HUDSON
ENGINEERING
&
CONSULTING, P.C.

November 9, 2023

Re: Town of North Castle
Proposed Single-Family Dwelling
6 Cannato Place
Section 101.01, Block 1, Lot 45

We have received your comment memo dated September 8, 2023, and offer the following responses on behalf of the applicant:

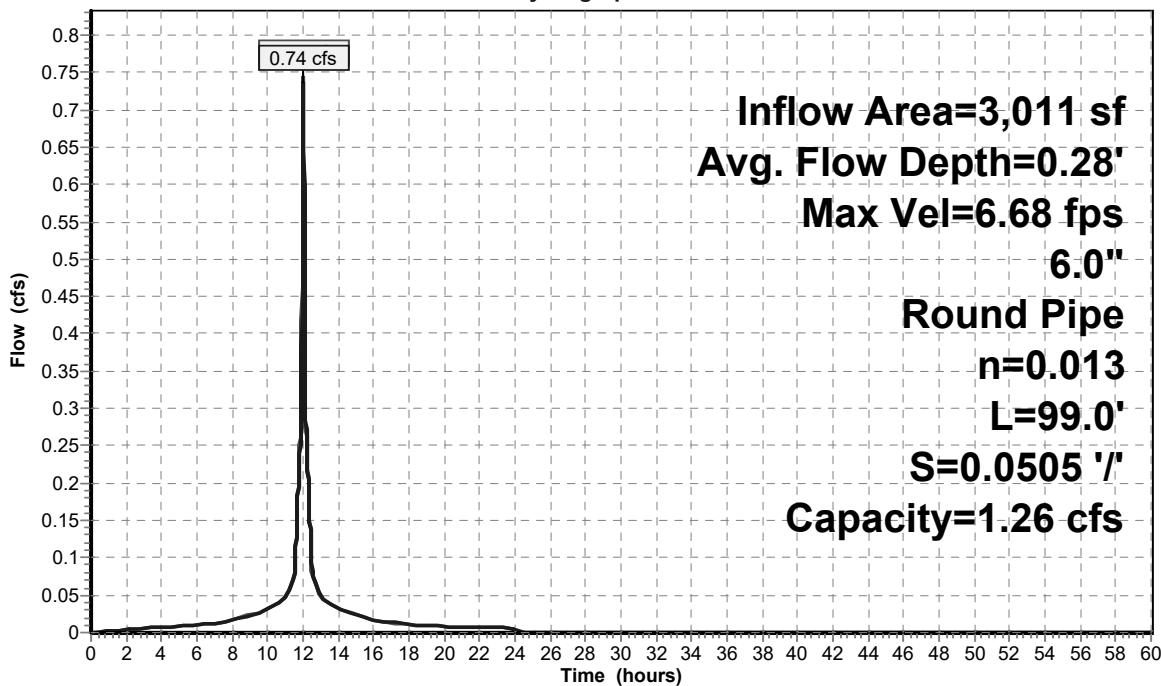
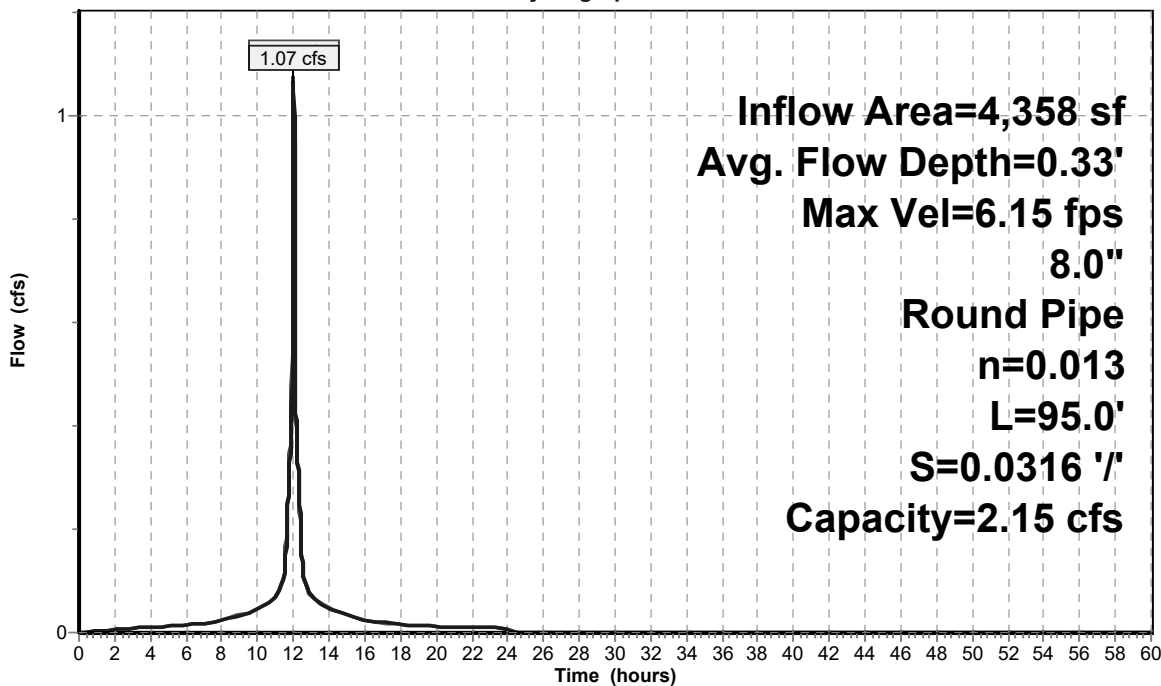
3. The applicant should submit calculations confirming that the 6" diameter drainpipe along the front of the proposed residence has sufficient capacity to convey runoff from the roof and driveway.

See revised Stormwater Narrative. Pipe calculations are now included.

DRIVEWAY PROFILE
(STA. 0+00 TO STA. 2+21)
HORIZONTAL SCALE: 1\"/>

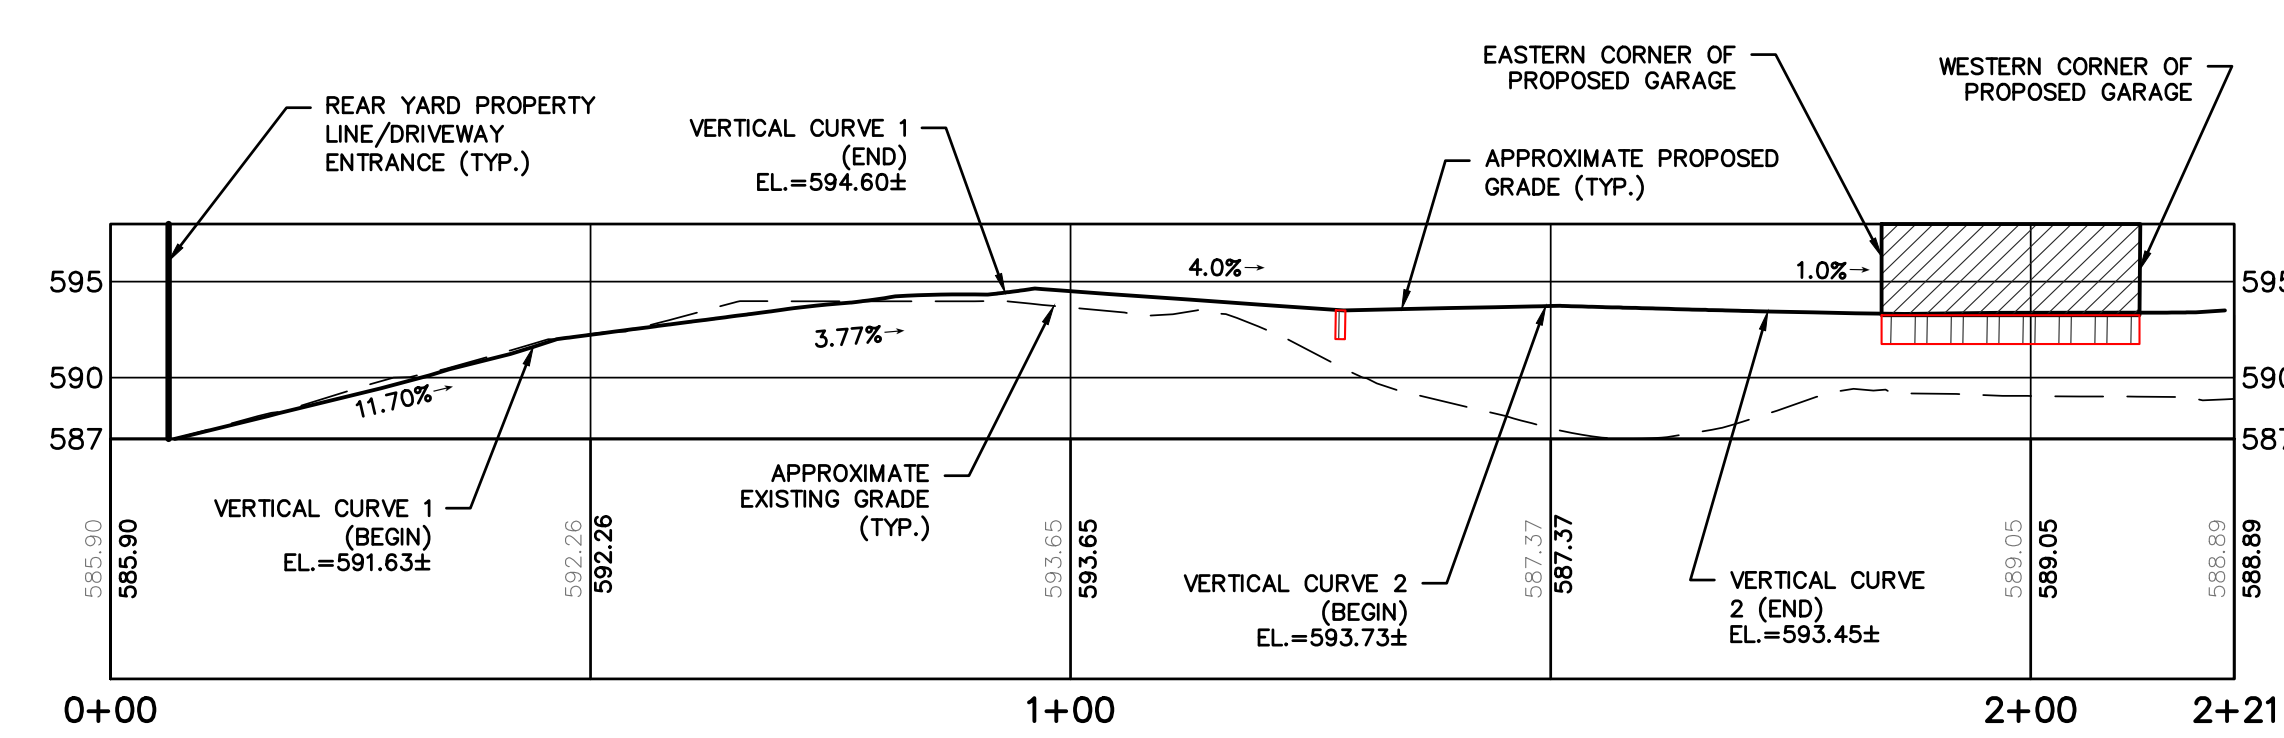
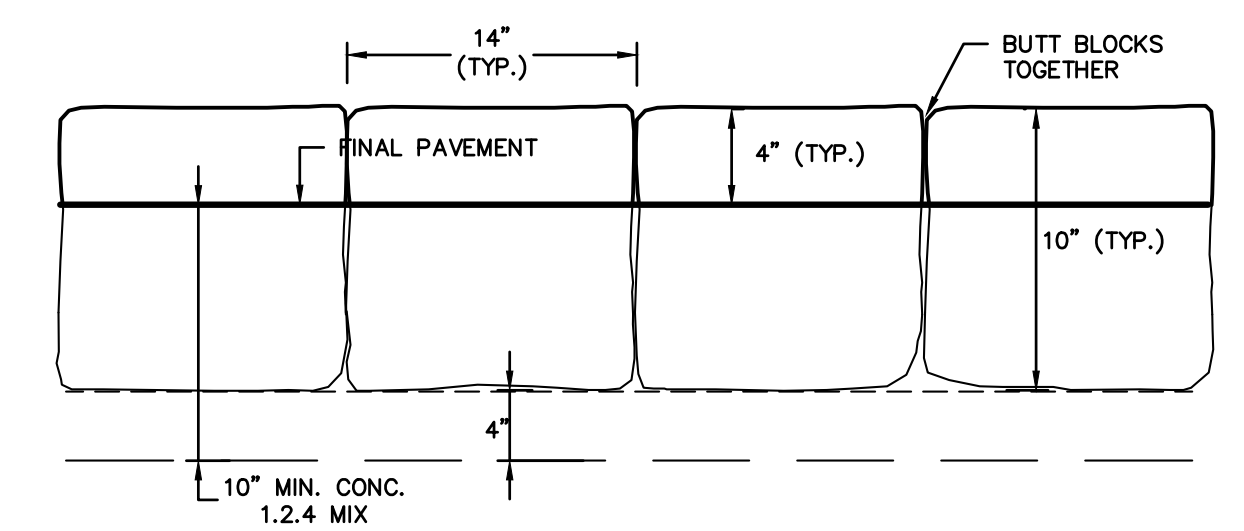
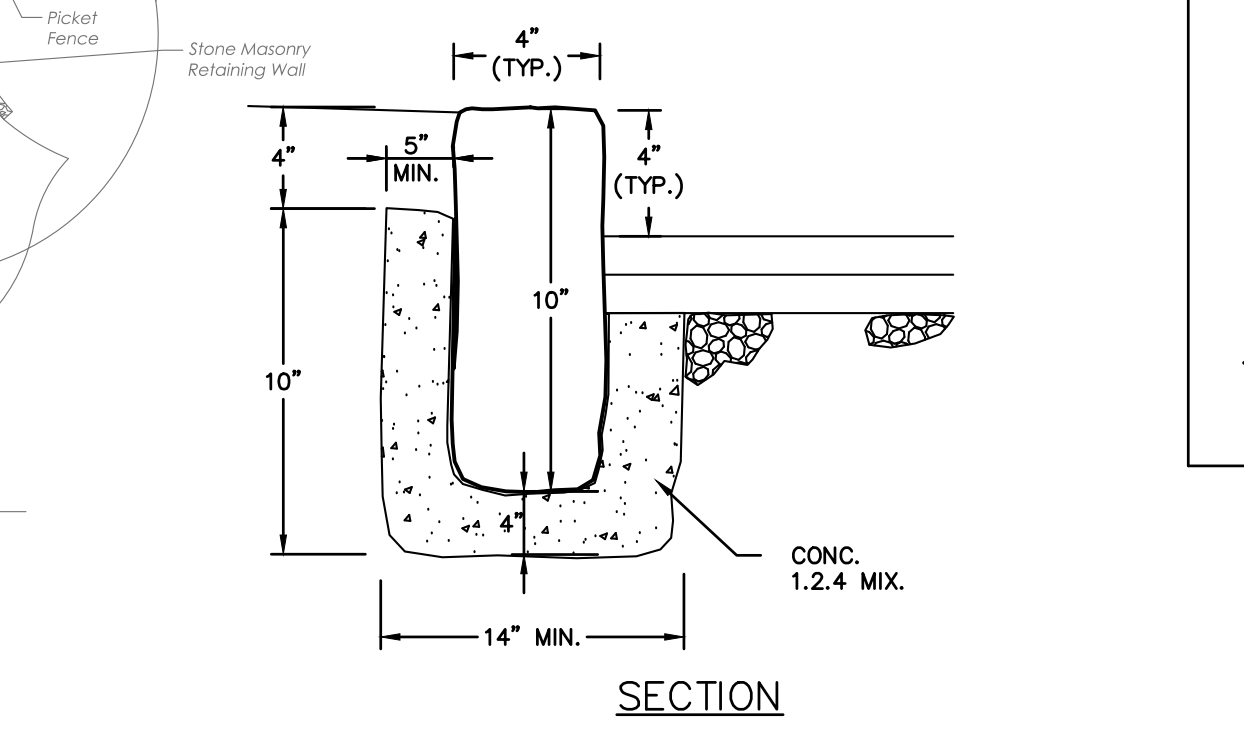
4. The applicant has provided a driveway profile for the proposed driveway. Additional detail would be helpful in reviewing the design and constructing the driveway. Please include the existing portion of driveway approaching the proposed driveway so the transition can be understood, vertical curves where changes of grade occur and proposed finish grade elevations along the drive. Please also show on the profile the location of drainage structures, rim elevations and location of the garage. Please provide driveway stationing on the Site Plan.

See revised plan sheet.
